BREAKERS
HOTEL
RENOVATION

Breakers Hotel Elevator Tower Height Increase Request

Breakers Hotel Window System Approval
November 7, 2019

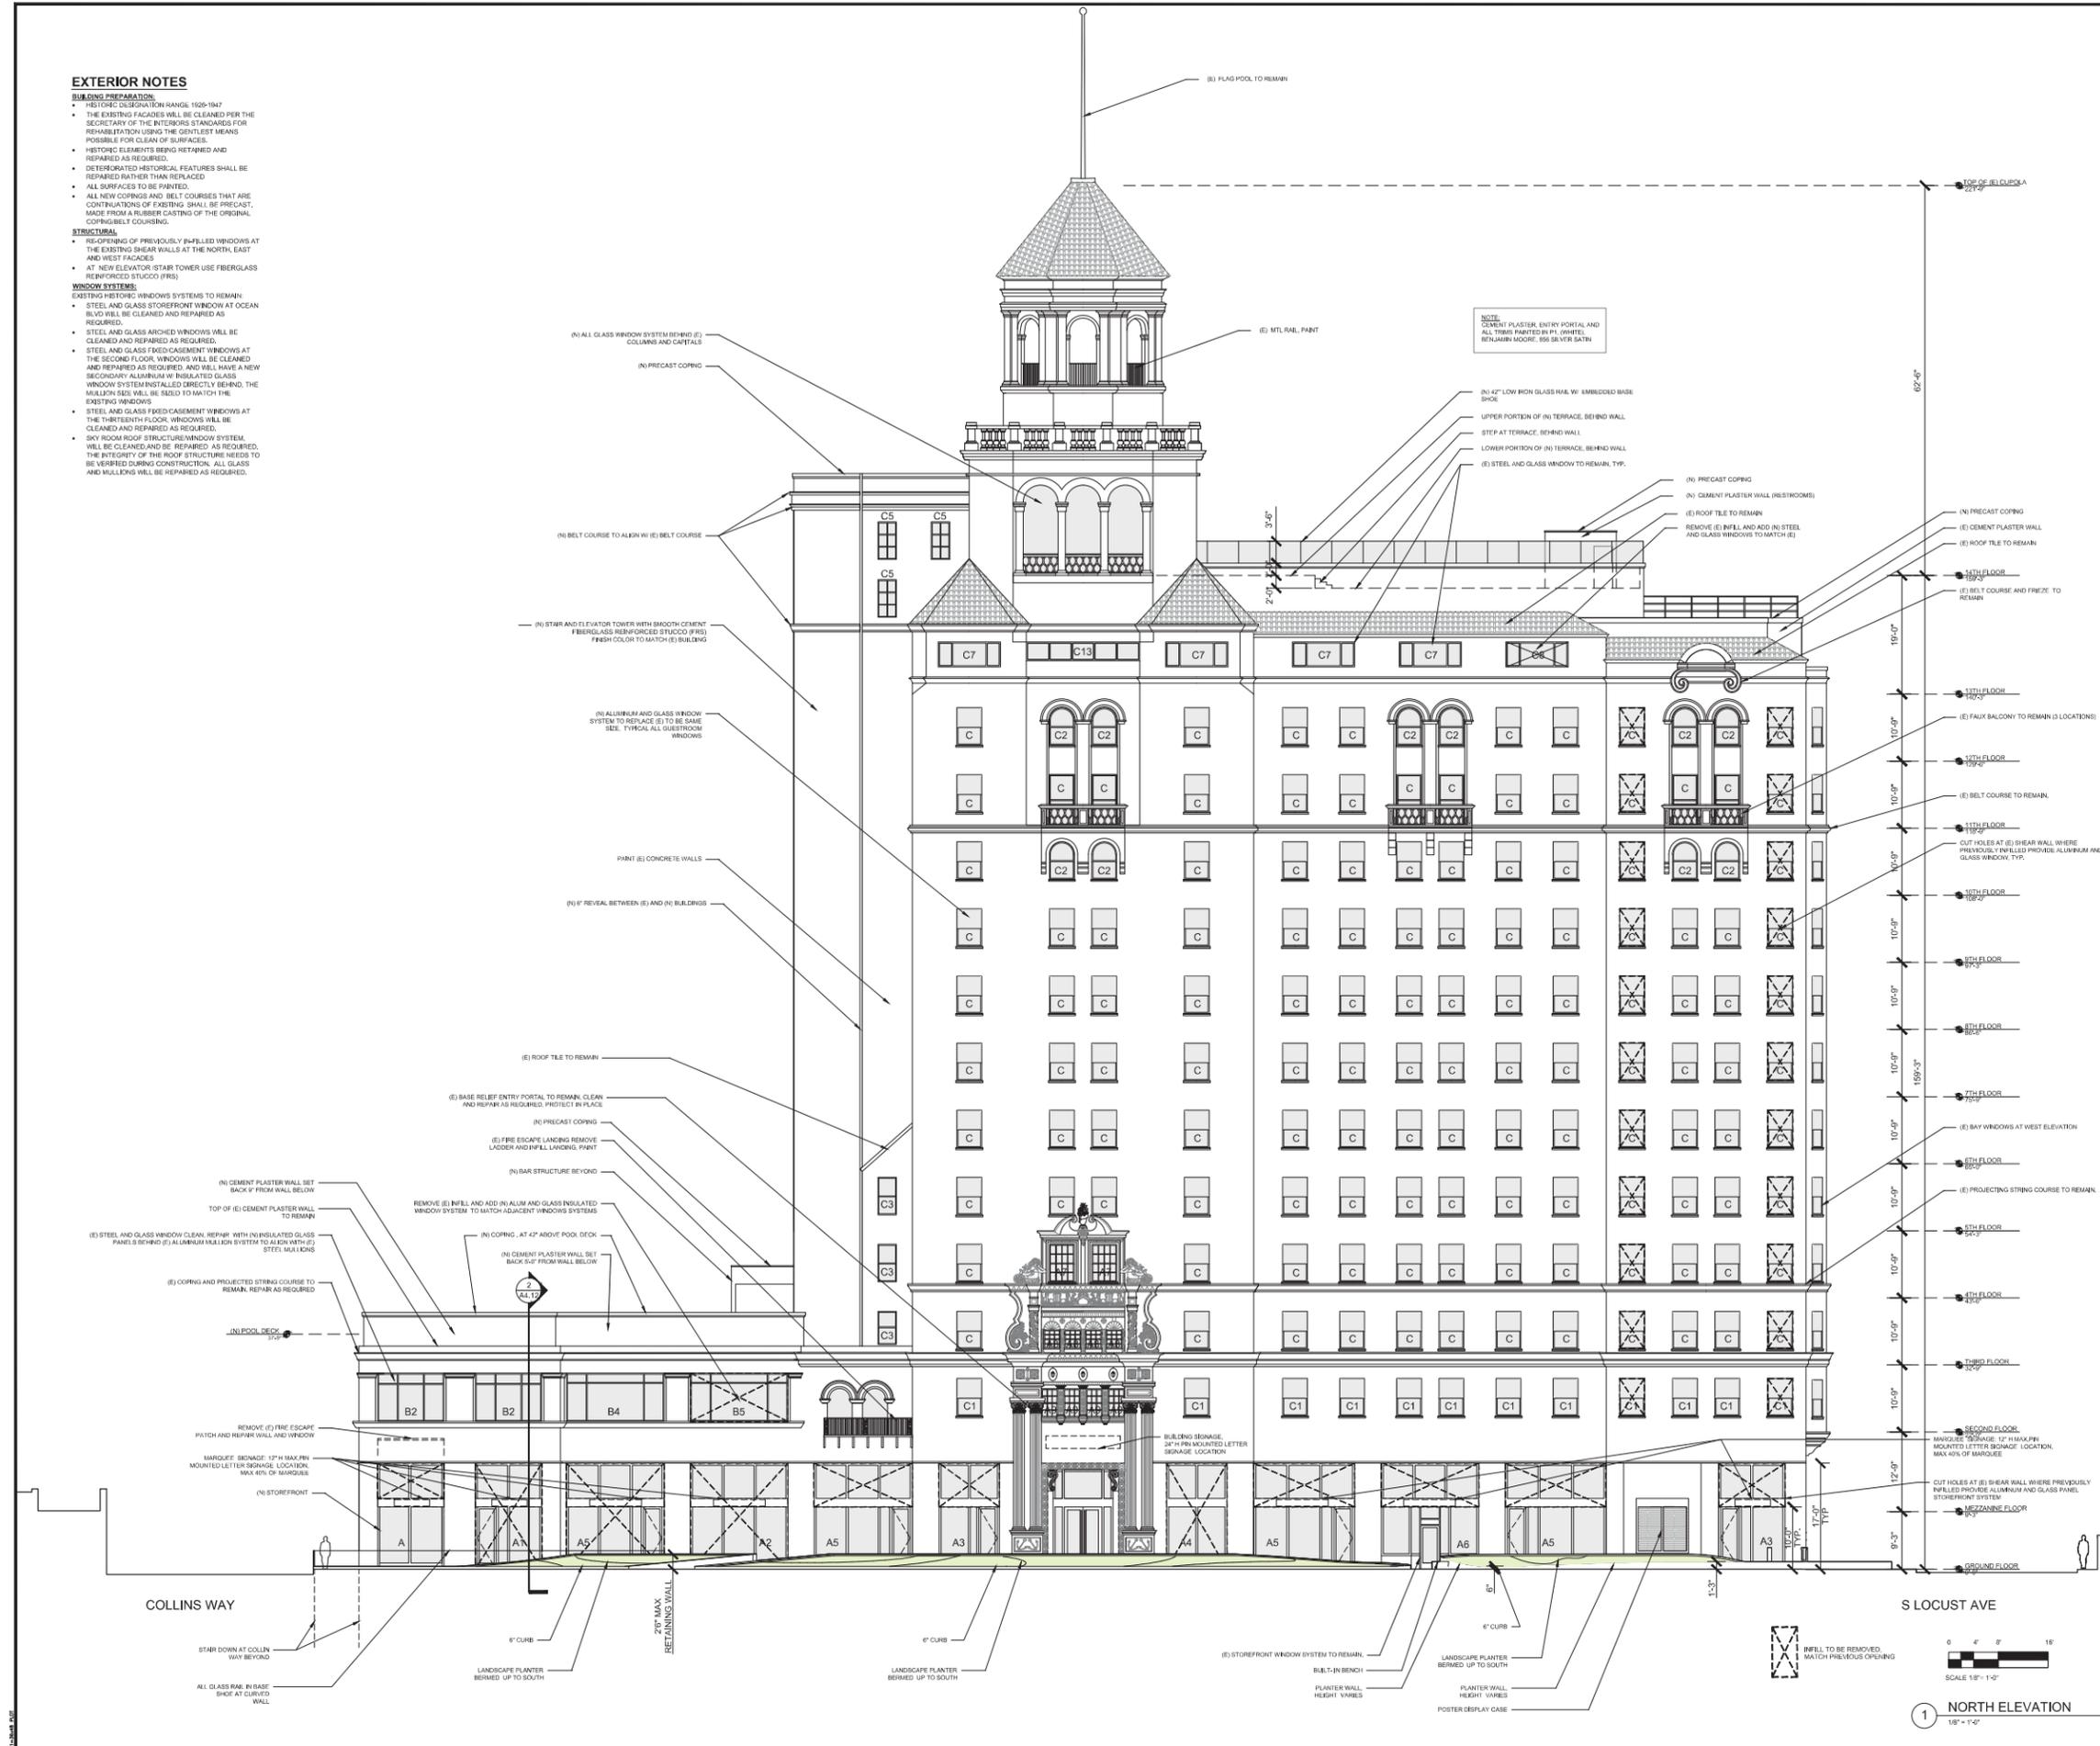
Shortly after receiving project approval, the general contractor removed one of the existing vinyl windows on the north elevation, 2nd floor, and installed one of the approved windows. Alejandro Plascencia reviewed the installed window with his superior Christopher Koontz and issued the statement below:

“The window is not approved for the building. While the window has some profile to it, it still reads as flat when viewing it from across the street at different angles. The window sash should be bulkier, and the separation between upper and lower glazing should be more pronounced.”

Though we respect Alejandro Plascencia and Christopher Koontz's opinion, we disagree with their comments, and believe the window meets the proper historic profile, as noted in the attached exhibit, and should be accepted as previously approved. Significant due diligence efforts were made to find a window system that was compatible with the historical nature of the building. All of this information was transparently presented and shared with the various reviewing parties at the City. As such, the project budget was established, financing was put in place, and the construction schedule was organized, based on this approval.

We respectfully request that you re-approve the window system previously presented and assist us in avoiding additional unnecessary project costs and delays.
